Not Duly Made Response 08/04/22

1. Application Form C2, Section 6 – Environmental Risk Assessment.

Location of ~~CX~~ Tank:

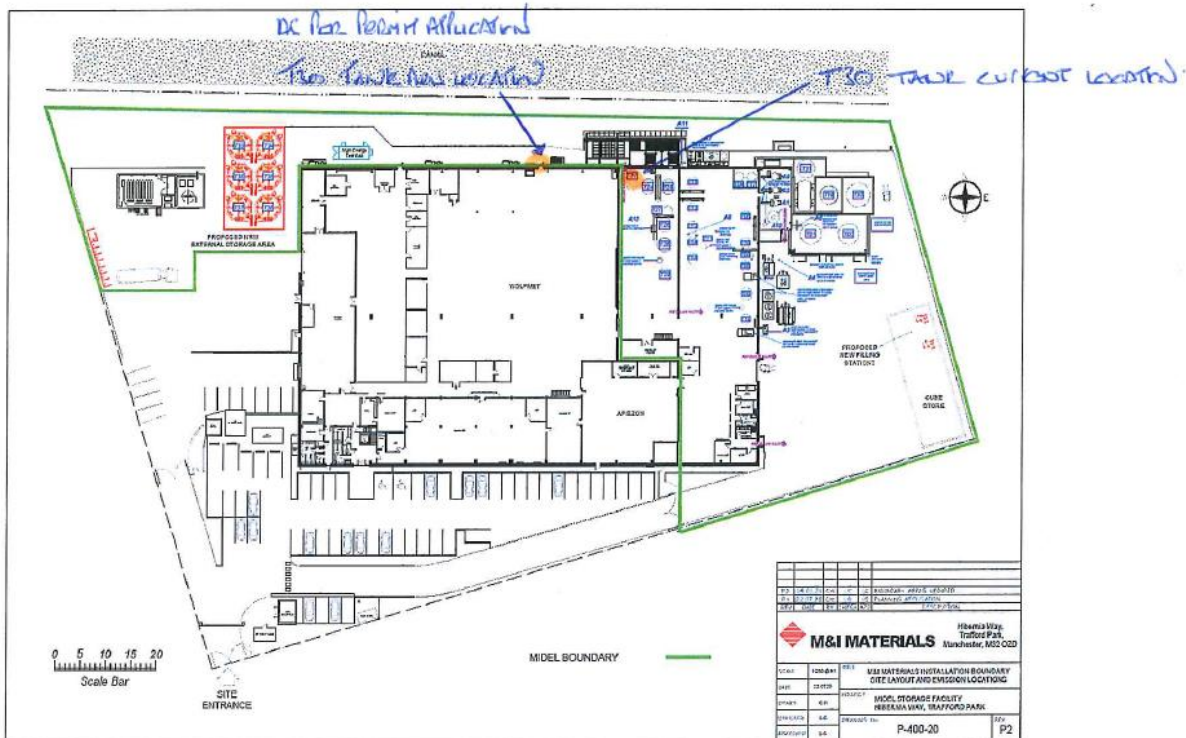
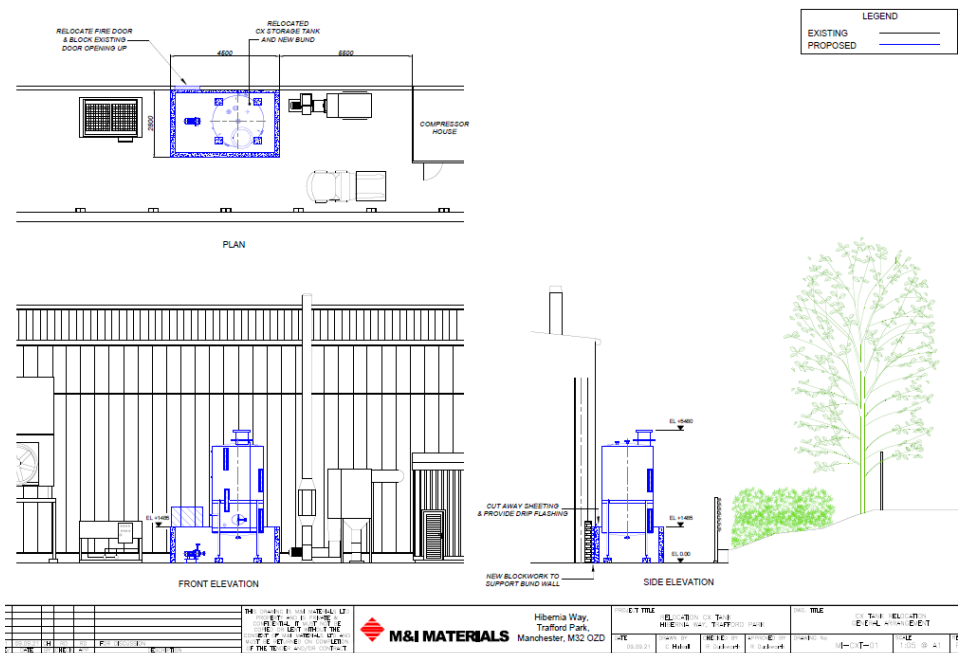
The Environmental Permit Variation Application supporting document states “For the upgrade, no modifications to the external building are needed other than installing a newly constructed external bund within the existing permit boundary for the of [REDACTED] tank (T30). An internal wall will be moved, (which will involve taking additional space from the adjacent manufacturing area). Reactor 3 will be installed adjacent to reactor 2 (T25)”.

i. Confirm if this a new tank and new bund, if so, demonstrate they meet the construction, maintenance and capacity requirements of CIRIA C736 (containment systems for the prevention of pollution) available from link:

As highlighted in the original variation application supporting document the existing ~~CX~~ tank (T30) 12000 litre stainless steel tank will be moved to an external location within a purpose-built new epoxy coated chemical resistant concrete bund.

The tank will be placed within the engineered concrete bund designed to meet BAT (the specification and constructed methods comply with CIRIA guidance C736) and will be served by the existing tanker loading point which is already provided with appropriate containment.

The vessel is equipped with level controls, overfill protection and temperature monitoring all linked to a SCADA control system with monitoring and alarm functions.
